FIRE SAFETY INSPECTION REPORT

MANTA APPARELS LIMITED.

ACCORD
on Fire and Building Safety in Bangladesh

March 30, 2014

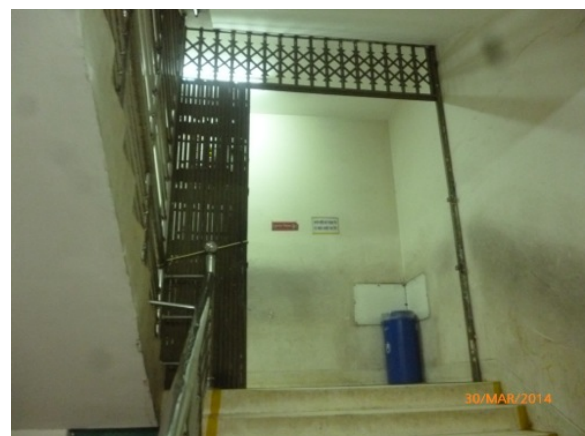
F-3	Fire Rated Construction	The exit stairs are not separated from work areas on each floor by fire-rated construction.	Provide minimum 1.5-hr fire rated doors and seal all unprotected openings to separate the exit stairs from work areas and other building spaces on all floor levels. Ensure that the fire doors are self-closing and positive latching and that they are provided with fire exit (panic) hardware where serving production floors.	Within 3 months
			If fire doors are required to be held open for functional reasons, provide automatic-closing devices tied to the fire alarm system.

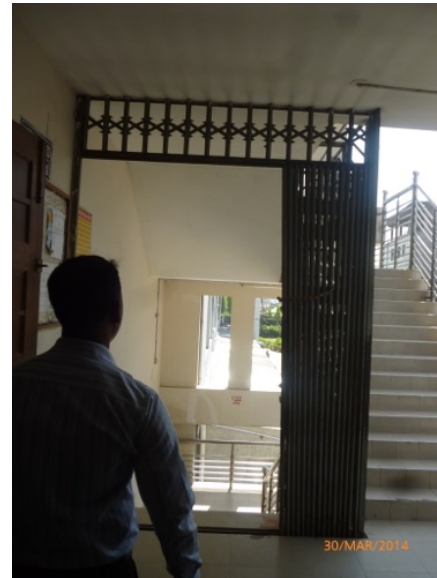
F-5	Egress	Egress doors and gates with locking features are provided at building exits, exit stairs and exit discharge. All gates and doors were open and unlocked during the inspection.	Remove locking features from all egress doors / gates. If locks are required for security reasons, utilize special door locking features complying with NFPA 101.	Immediate
-----	--------	--	---	-----------
